Ivins City Staff Report
City Council Meeting 3/4/2021

Agenda Item: Discuss and consider approval of an additional expenditure of $4,444 for storm drain pump and parking lot modification for the new City Hall.

PROPOSAL REQUEST 004

ARCHITECT'S SUPPLEMENTAL INSTRUCTIONS 017

4.1 **Pump at Storm Drain**

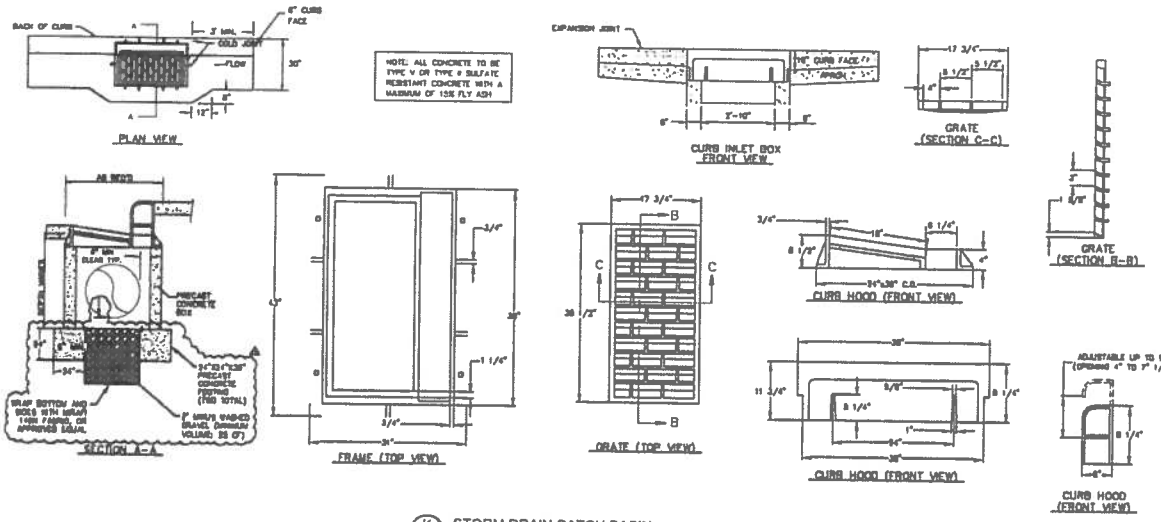
-Add pump with required electrical work to storm drain at curb inlet box at Southeast corner of site.
-See attached memo from BNA outlining electrical and pump size requirements.
-See attached drawings from Alpha Engineering showing location of inlet box and details.

K STORM DRAIN CATCH BASIN
NTS
D&L MODEL I-3517

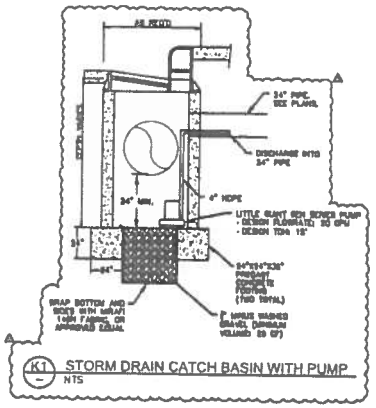
- The curb inlet at Sta:82+54 will have a 1/3HP pump inside the box. Provide pump with a weatherproof thermal disconnect and 120V dedicated circuit from Panel 'P1' utilizing spare 20A breaker. Coordinate exact curb inlet and pump location with civil drawings.

17.1 Parking Lot Grading

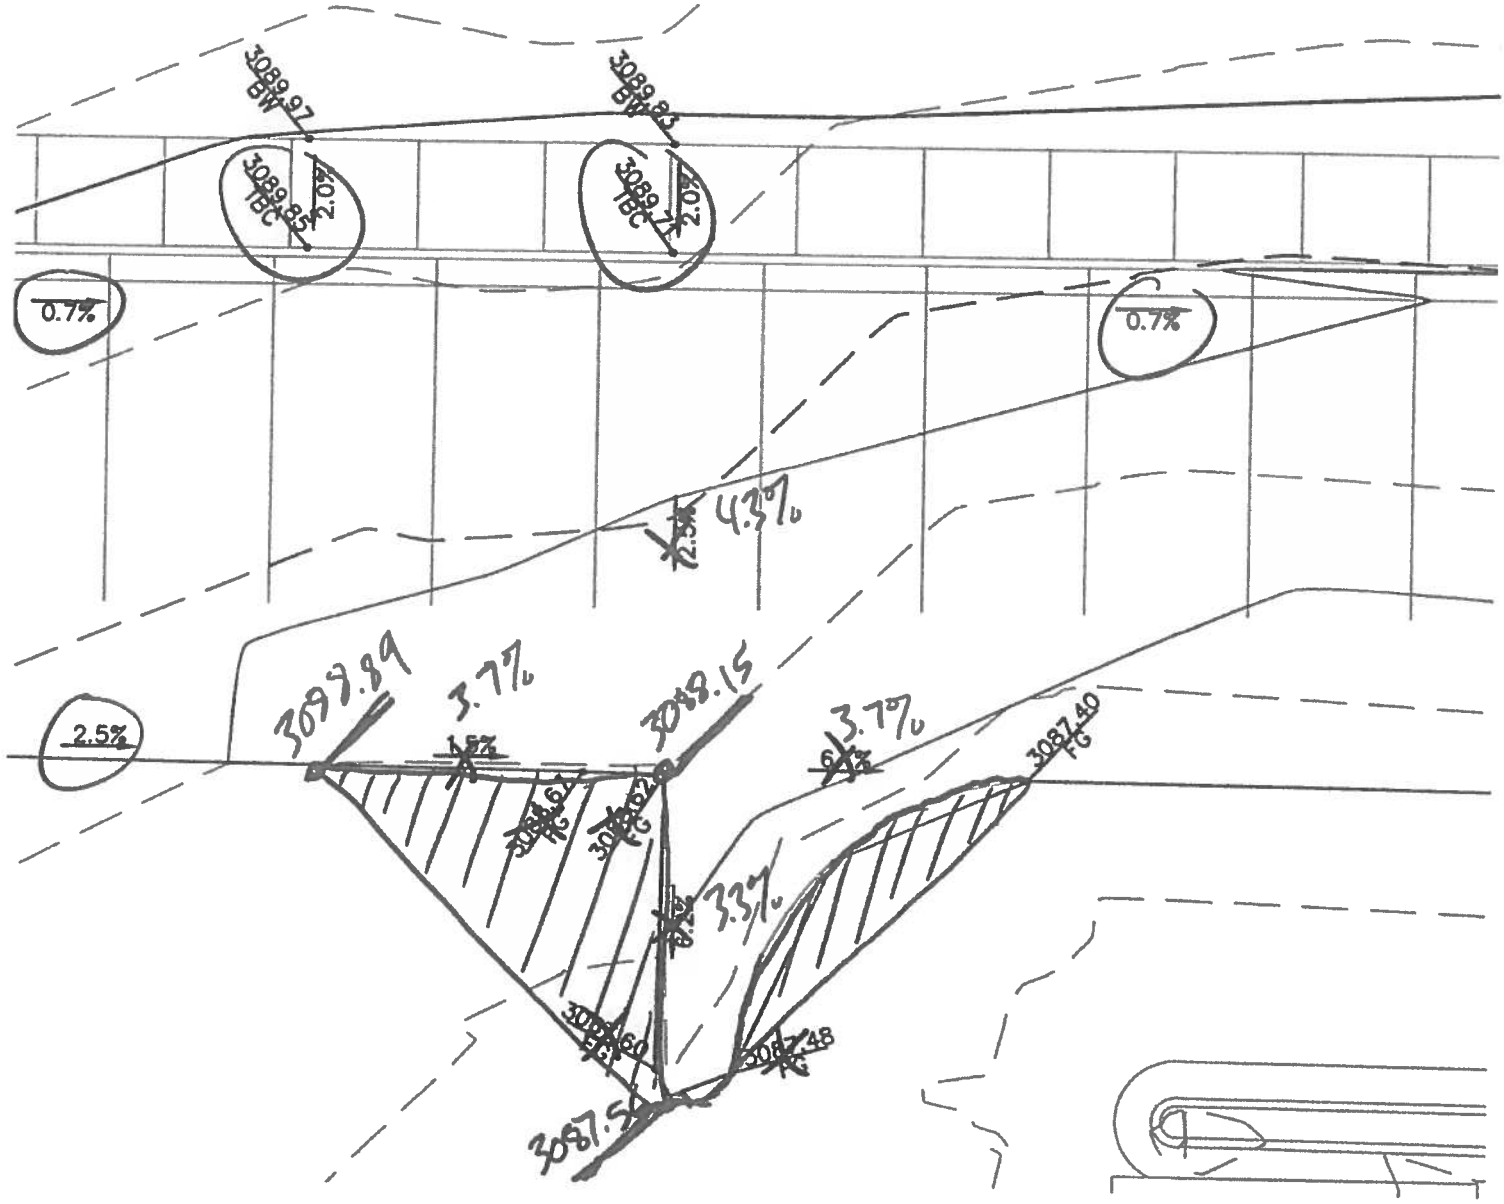
- Remove asphalt at South parking lot where existing curb protrudes into parking area as indicated in attached sketch. Grade existing subsurface to meet indicated elevations. Replace asphalt.
